Well Name: DIAMOND 6 FEDERAL	Well Location: T25S / R34E / SEC 6 / NENW / 32.1609024 / -103.5163864	County or Parish/State: LEA / NM
Well Number: 02	Type of Well: OIL WELL	Allottee or Tribe Name:
Lease Number: NMNM14497A	Unit or CA Name:	Unit or CA Number:
US Well Number: 3002536628	Operator: EOG RESOURCES INCORPORATED

Type of Submission: Notice of Intent

Type of Action: Plug and Abandonment

Diamond 6 Federal #2H – P&A Procedure

KB:
 GL: 3460
 14.750"
 11.750" 42.00# @ 650
 750 sx = surface
 TOC @ 5190
 11.000"
 8.625" 32.00# @ 5445
 1430 sx = surface

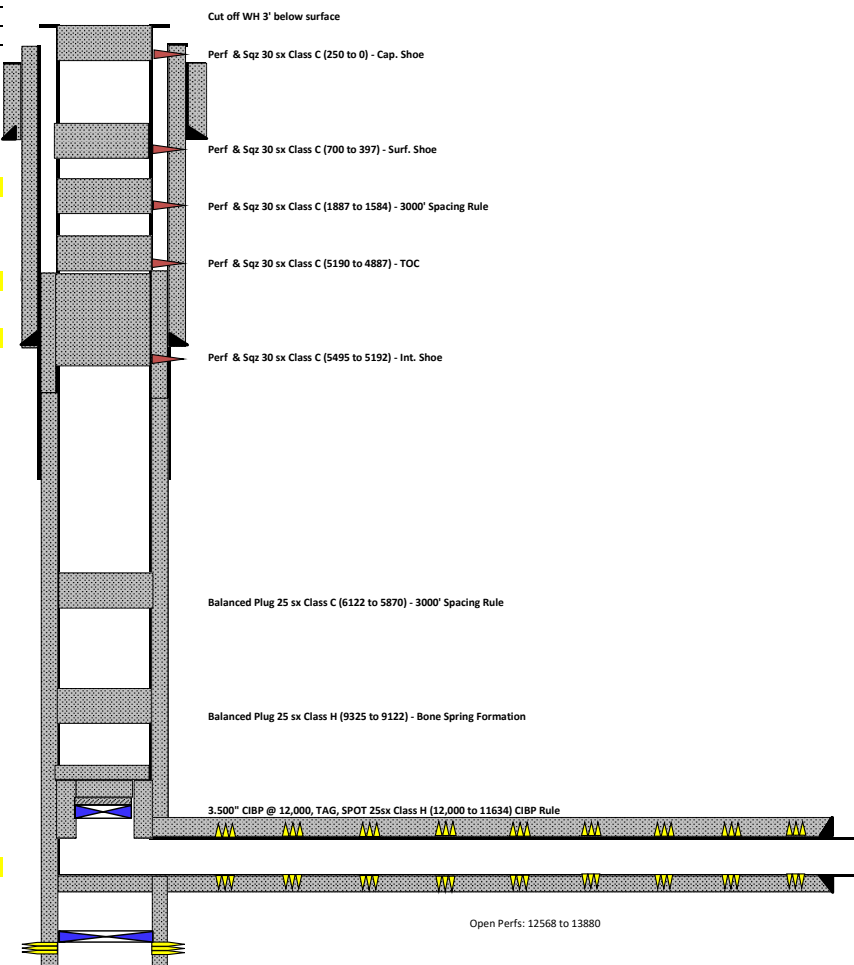
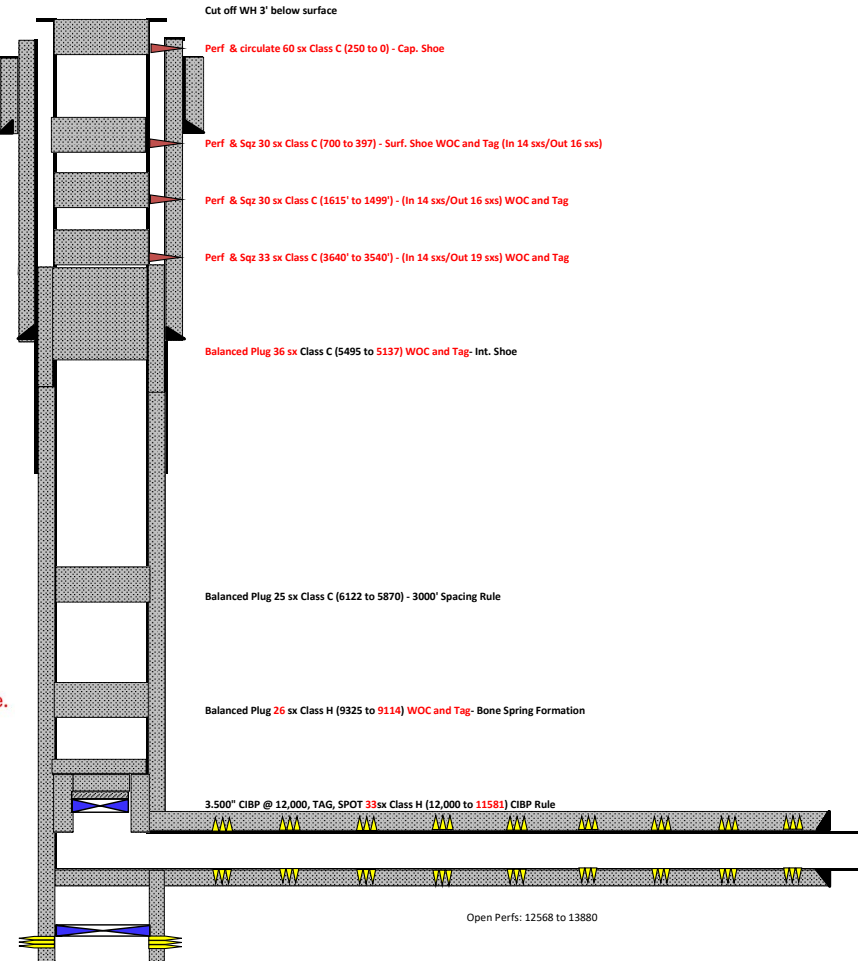
*Run CBL from CIBP to surface.
 Submit results to BLM.

REVISED
 10:19 am, Mar 04, 2026

7. RIH, top 3.500" CIBP w/ 33 sx Class H on CIBP, 12,000 to 11581. CIBP Rule. WOC. TAG.
8. Pick up, set balanced plug w/ 26 sx Class H from 9325 to 9114 for Bone Spring Formation.

9. Pick up, set balanced plug w/ 25 sx Class C from 6122 to 5870 for 3000' Spacing Rule.
10. Pick up, set balanced plug w/ 36 sx Class C from 5495 to 5137 for Int. Shoe. WOC. TAG.

11. Pick up, perf & squeeze plug w/ 33 sx Class C from 3640' to 3540' for base of salt. (In 14 sxs/ Out 19 sxs) WOC. TAG.
12. Pick up, perf & squeeze plug w/ 30 sx Class C from 1615' to 1499' for top of salt. (In 14 sxs/Out 16 sxs) WOC. TAG.

13. Pick up, perf & squeeze plug w/ 30 sx Class C from 700 to 397 for Surf. Shoe. (In 14 sxs/Out 16 sxs) WOC. TAG.
14. Pick up, perf & circulate plug w/ 60 sx Class C from 250 to 0 for Cap Shoe.
